Install Rear Drive Unit Inverter Coolant Manifold Bolt

Classification	Campaign Bulletin	Section/Group	40 - Rear Drive Unit	Country/Region	United States
Year	2017	Model	Model 3	Version	All

Figure 1

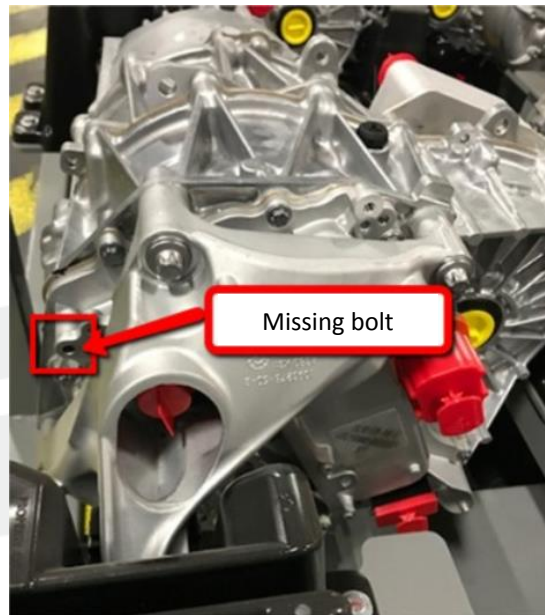
On some Model 3 vehicles, one of the bolts that helps to secure the rear drive unit inverter coolant manifold to the inverter housing might not have been installed. Consequently, coolant might leak from the manifold.

3. Take a photo of the rear drive unit inverter coolant manifold in the area between the LH side of the rear subframe assembly and the body, and upload the photo to Toolbox. Do this whether the bolt is installed or missing (Figure 1).

8. Install the bolt that secures the rear drive unit inverter coolant manifold to the inverter (torque 10 Nm).
9. Take a second photo after the bolt is installed, and upload the photo to Toolbox. Make sure that the newly-installed bolt is clearly visible in the photo.
